UNITED STATES PATENT AND TRADEMARK OFFICE

APPLICATION NO.	FILING DATE	FIRST NAMED INVENTOR	ATTORNEY DOCKET NO.	CONFIRMATION NO.
09/905,099	07/16/2001	Kenji Kawazoe	1272.C0468	3548

Office Action Summary

DETAILED ACTION

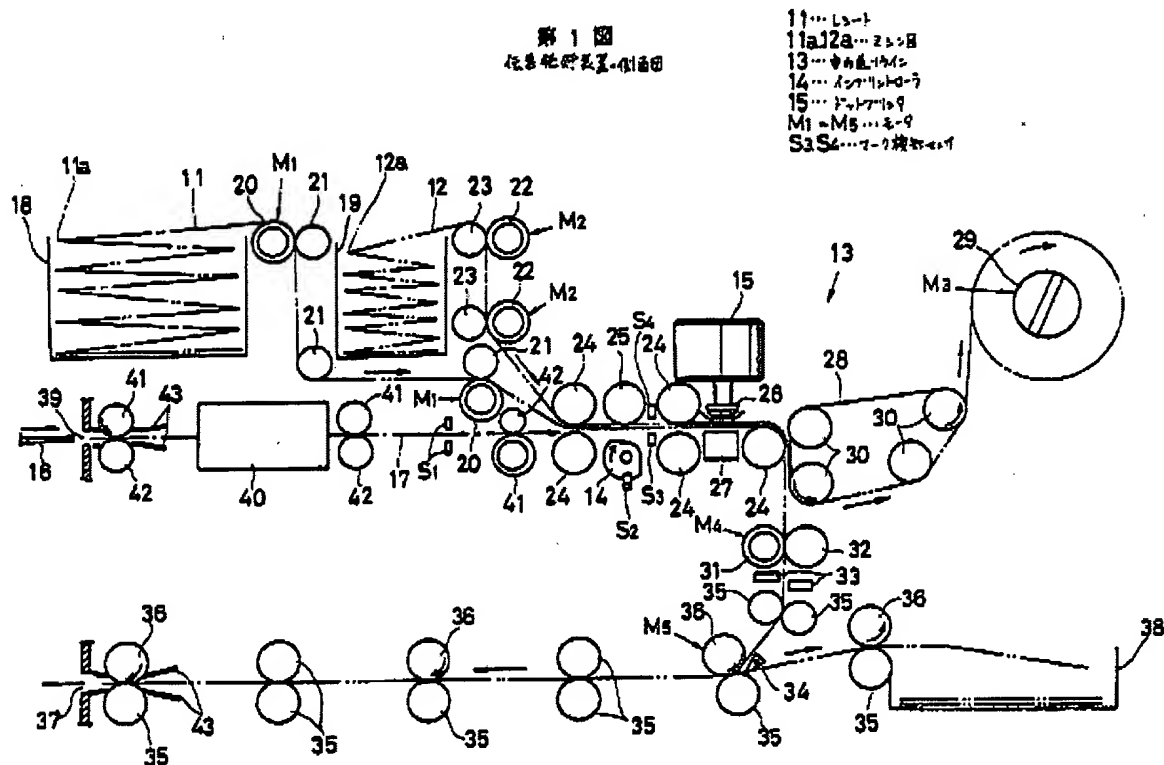
With respect to claims 1-4 and 8-11, Morishita et al. discloses in combination, a printing apparatus and a print medium and a method of manufacturing a print medium to be supplied to a printing apparatus wherein the printing apparatus (Figure 1) comprising a feeding means element 23) for feeding the print medium accommodated in an accommodating portion (element 19) to a transporting passage facing the printing means (element 15) and transports the print medium by feeding means along the transporting passage so that the printing means can print on the print medium and a front end of the accommodating portion being positioned a predetermined distance from the feeding means (Fig1), the printing medium comprising:

- A print area on which to print a desired image (Fig.1: element 11)
- A separate discard area provided in at least a front end portion of the print medium (Fig.1)

- A width of the discard area provided in at least the front end portion is greater than the predetermined distance from the front end of the accommodating portion to the feeding means or a distance from a front end of the accommodating portion to the feeding means is less than a width of the discard area in the front end portion of the print medium (Fig.1)

- A discharge means being positioned a predetermined distance from a rearmost effective printing portion of the printing means (Fig.1)
- A width of the discard area provided in at least the front end portion is greater than the predetermined distance from the rearmost effective printing portion of the printing means to the discharge means (Fig.1)

- Transport means being positioned a predetermined distance from a front-most effective printing portion of the printing means (Fig.1)
- A width of the discard area provided in at least the rear portion is greater than the predetermined distance from the front-most effective printing portion of the printing means to the transport means (Fig.1)

【圖9】

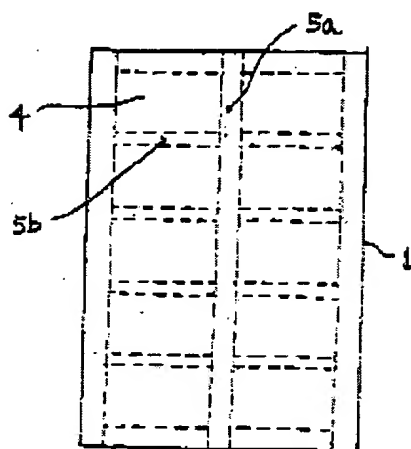
Yamaoka teaches plurality of print areas and separably discard areas before and after each print area and a discard area in a left end portion of the print medium and a discard area in a right end portion of the print medium are set equal in width. (Fig.9). Also, in figure 9, Yamaoka teaches that the widths of the discard areas in left and right end portions of the print medium are greater than a length in the transport direction of the discard are between the print areas.

Furthermore, using the combination of Morishita et al. and Warabiki et al, the discard areas in the front and rear end portions of the print medium is a full length of a page of web, so it clearly show that the discard areas in the front and rear end portions of the print medium in Morishita is greater than the discard area between the print areas in Yamaoka et al.
